SECOND ADDENDUM TO THE ENVIRONMENTAL IMPACT ASSESSMENT

FOR
GRAND PALLADIUM
LADY HAMILTON
RESORT & SPA
AT POINT, HANOVER

COMMENTS RE FIESTA EIA

A review of the above-mentioned document was conducted by representatives of the Internal Review Committee of NEPA, supported by written comments received from the Mines and Geology Division and the Water Resources Authority and verbal comments received from the Environmental Health Unit. The following comments are being represented to you for your response:

DRAWING TITLE :
MASTER PLAN
- ARCHITECTURAL -
MAIN FLOOR PLAN
WITH PROPOSED
DRAINAGE

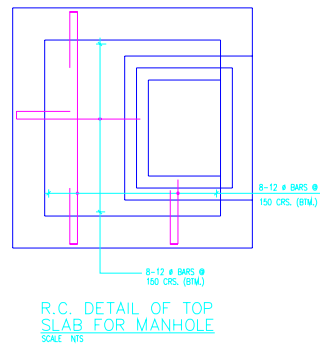
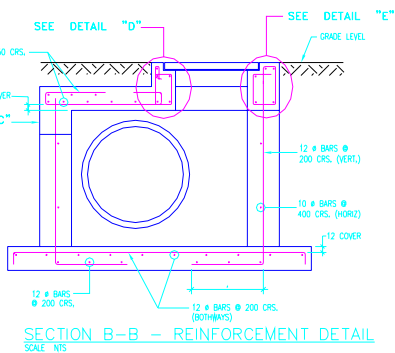
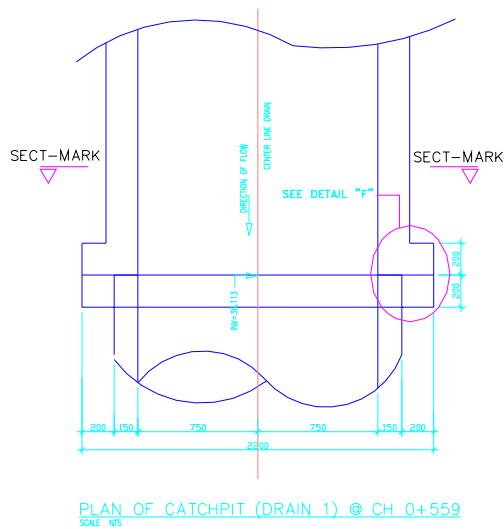
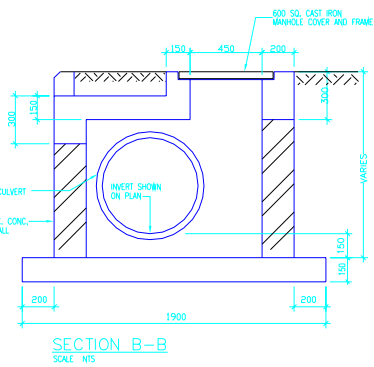
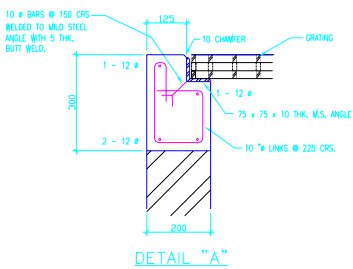
- 1 There is a need for the development of a **full** understanding of pre-development natural drainage on site, including major and minor drainage flood limits and discharge rates (these must be mapped).
- 2 There is a need for the development of a **full** understanding of the post-development influence on existing flood limits / discharge rates (these must be mapped).
- 3 The information obtained from the two points mentioned above must then be used to determine the areas on the development where the specific location of the intervention measures outlined in the EIA are to be positioned.
- 4 There must also be serious considerations given to the use of other drainage mitigation measures, particularly those designed to minimize site water collection, promote retention and slow the movement of runoff.

All of the mitigations decided on after the review of the comments outlined above must be represented in the form of a comprehensive drainage mitigation plan **which must be submitted to the National Works Agency for approval**. This approval **will be required for incorporation as a condition of the Environmental Permit** that would be issued for the development once an agreement on the outcome of the EIA can be arrived at.

- a) Utilize a double French Drain on the Northern side of the main road. This will intercept the stormwater (containing silt) and filter the silt and slow down the flow rate so that scouring will be minimized.

The two French drains would be separated by a membrane such as geo textile. This lining will serve to trap and keep sediments out of the drain. These drains will discharge into the drains on the northern side of the main road.

- b) Utilize a series of sedimentation basins on the northern and southern sides of the main road. Details of the types and sizes of the various compounds will be the subject of the detailed design. In addition, special components (such as baffles) will be included in the sedimentation basins to enhance settling.

- e) In order to reduce the amount of stormwater flowing overland to the sea, it is proposed to use a series of gutters to collect the run-off from the top of the buildings and deposit it in the sea without making contact with the ground. This flow will be free of any sediments or nutrients.

The layout and proposed locations of the mitigation features described above are presented on the attached maps – Figures 1 and 2.

FIGURE 3: 10, 25, 50 AND 100 YEAR RETURN PERIOD FOR WAVE HEIGHTS AT MONTEGO BAY

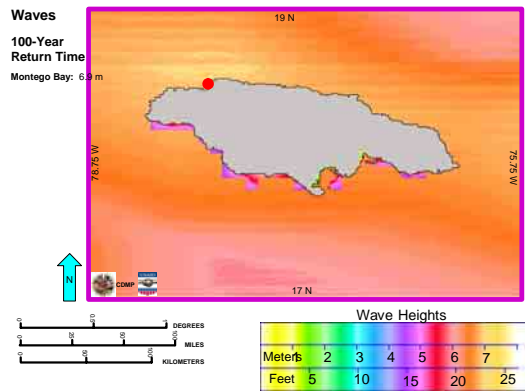
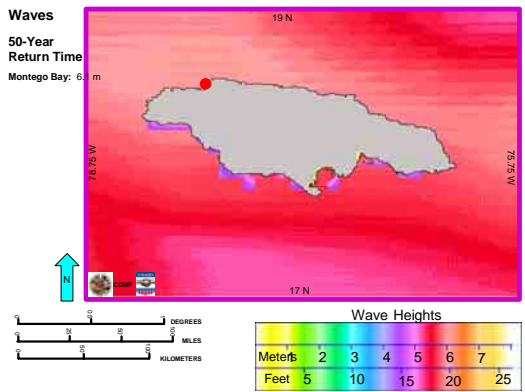
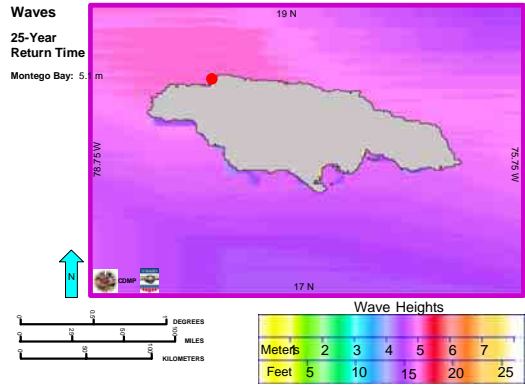
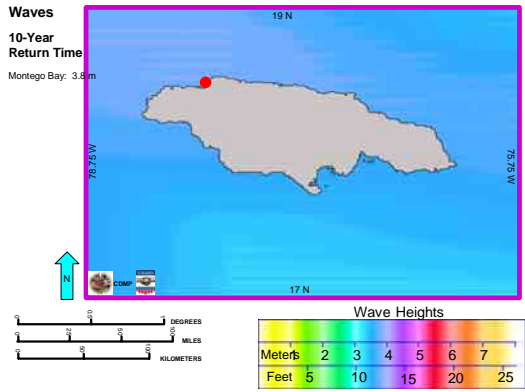
The Agency had expected to see a prediction of the wave run-up on the property due to a worst case scenario storm. Hurricane Allen, a category 5 storm passing north of the island, represents such a case. The modeling of the extent of run-up would show where wave/ building interactions could occur and where the current setbacks being used may have to be amended due to this information. Note that the planning setbacks are guides and speak to the use of local oceanographic information as a means of supplementing the guide information.

Using the TAOS model, Caribbean Disaster Mitigation Project (CDMP) has produced maximum likely estimates for surge and wave heights throughout the Caribbean basin for 10-, 25-, 50- and 100-year return periods. Estimates were made for each cell in a 30 arcsecond (approx 1km x 1 km) grid, covering the entire Caribbean. These maps are a result of new techniques for modelling storms and estimating the probabilities of storms, developed in part under the patronage of CDMP. This modelling was also done for individual islands using key locations. Four locations were used for Jamaica, of which Montego Bay is the closest to the project site.

It is recommended that these figures be used along with the setback guidelines issued by the Parish Council and other Agencies in respect of building setback from the high tide mark.
